Report of the Head of Development Management and Building Control Committee Report – Application Report

78998/APP/2024/2281

Site Address: **Ruislip Lido, Reservoir Road**

Proposal: **Replacement of existing 2 x single storey toilet facilities buildings at Willow Lawn and Woody Bay with 2 x single storey toilet and changing facilities buildings, and associated works and landscaping.**

Figure 14: Woody Bay Proposed Elevations

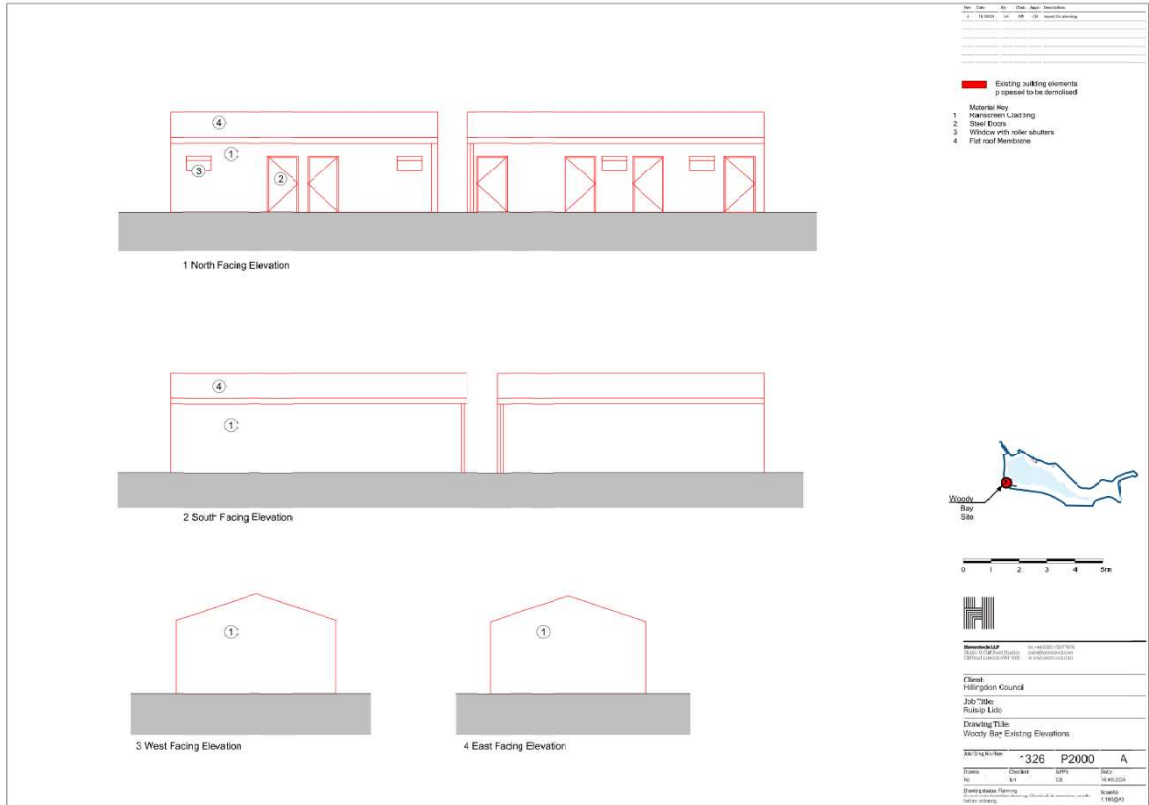
- 3.5 During the processing of the application the Local Planning Authority (LPA) identified that the buildings were overly tall and out-of-keeping with the natural character of the area.

- 3.6 The applicant has proactively responded to the feedback from the LPA to amend the scheme by reducing the roof pitch of the proposed facilities from 45-degrees to 40-degrees, thereby reducing the height of both buildings. The roof pitches were not reduced any further by reason that maintenance access with minimum floor to ceiling heights is required for a water tank to be contained within the roof space of the Woody Bay replacement toilets. The 40-degree pitch would also help to minimise debris such as leaves, sticks and bird feathers from sticking to the roof.

- 7.13 During the assessment of the application, revised drawings were submitted in response to LPA feedback reducing the pitch of the roofs from 45-degrees to 40-degrees, and by consequence also reducing the maximum heights of the buildings. These amendments addressed concerns of excessive height and

resultant poor visual outcomes. The amended 40-degree roof pitches would be less prominent while still maintaining the functionality of the higher pitched roofs with regards to debris clearance and internal height clearances for water tanks.
